UNITED STATES PATENT AND TRADEMARK OFFICE

10/822,064

DETAILED ACTION

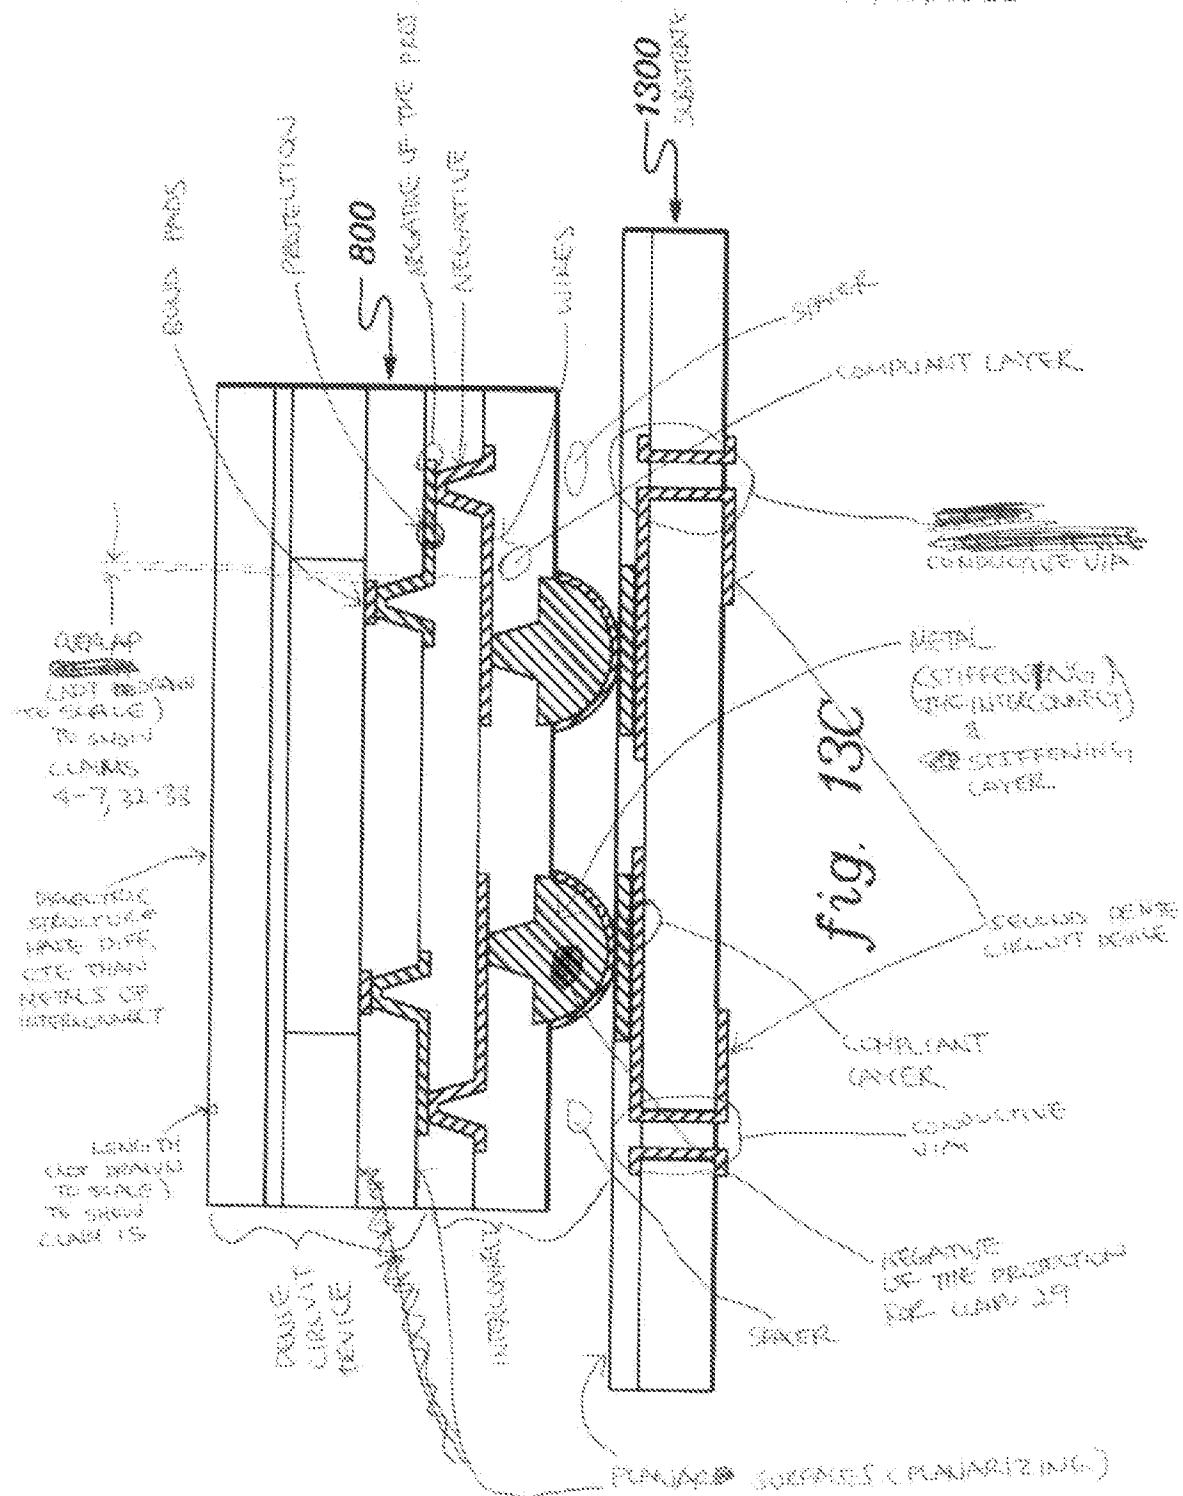
3. Claims 1-7 and 15-17 are rejected under 35 U.S.C. 102(e) as being anticipated by

Eichelberger et al (US 6,555,908).

Eichelberger discloses as follows:

The dielectric material of the interconnect forms a negative and receives and at least partially surrounds the projection as annotated above.

The dielectric material of the interconnect forms a negative and receives and at least partially surrounds the projection as annotated in Paragraph 2 above.

Wires are shown in Paragraph 2. In response to applicant's argument that the references fail to show certain features of applicant's invention, it is noted that the features upon which applicant relies (i.e., a slender, stringlike piece or filament of metal,) are not recited in the rejected claim(s). Although the claims are interpreted in light of the specification, limitations

Paragraph 2 shows overlap. Space and breath dimensions are so small that they are included in the overlap.

A compliant layer, a spacer and a second dense circuit device are shown in the annotation.

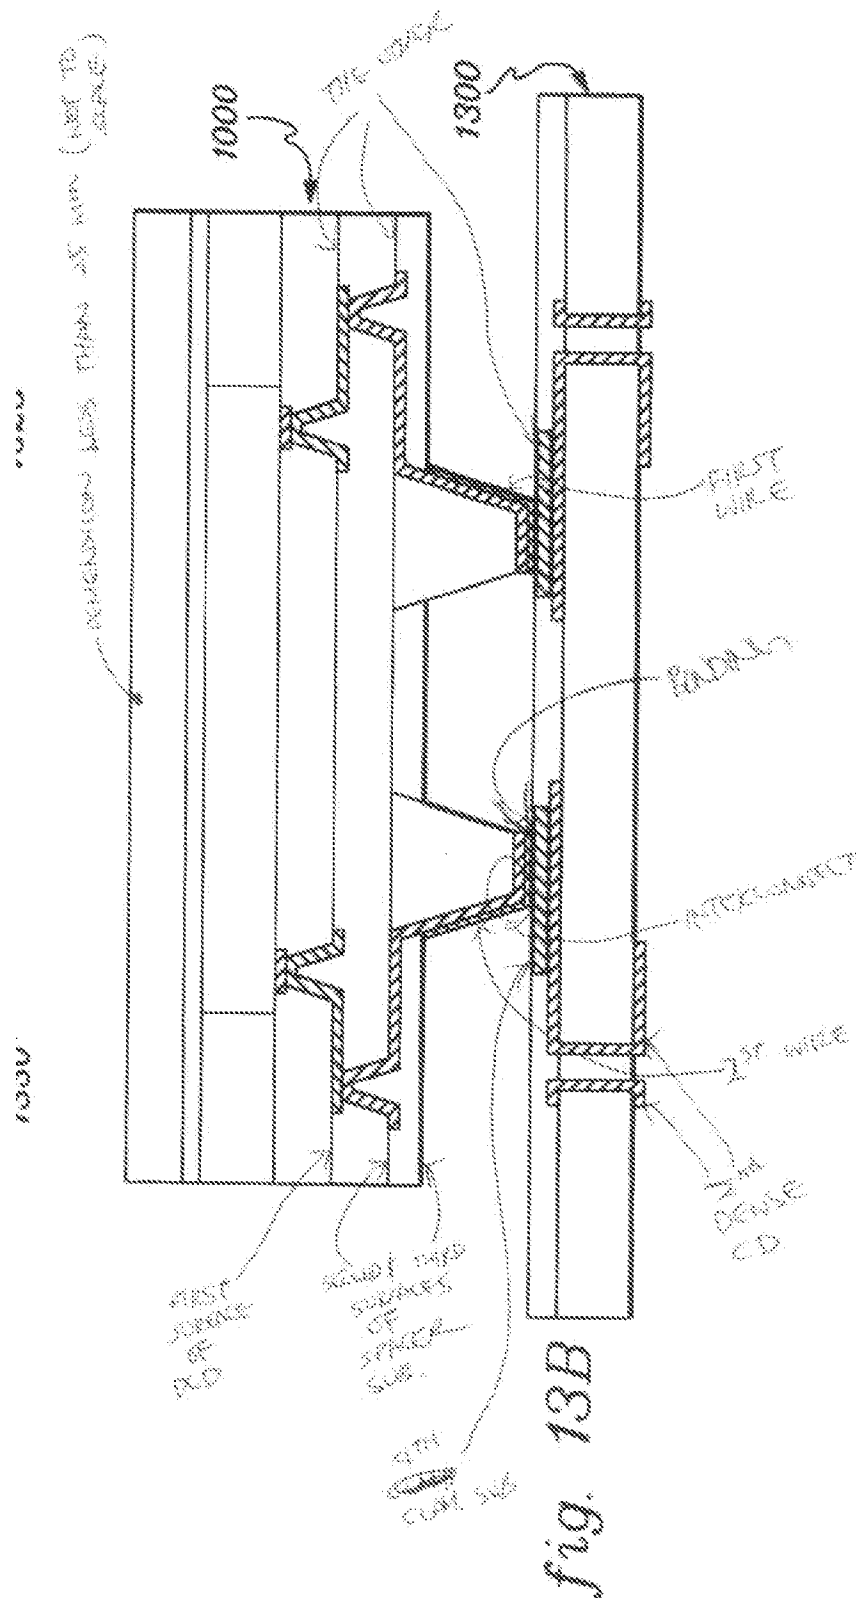
6. Claims 9, 12-14, 25-29, 31-39, 41-43 and 87 are rejected under 35 U.S.C. 103(a) as being unpatentable over Eichelberger et al (US 6,555,908) in view of Tong et al (US 6,962,835).

Eichelberger fails to disclose covalent bonding at RT. The dielectric material forms a negative and receives and at least partially surrounds the projection as annotated above.

Tong discloses covalent bonding at RT (metal-to-metal bonding (metals have loose electron outer valence shell) at RT; col. 9, lines 60-62).

It would have been obvious to one of ordinary skill in the art at the time the invention was made to modify Eichelberger by covalent bonding at RT, as taught by Tong, for the purpose of eliminating solder between metals.
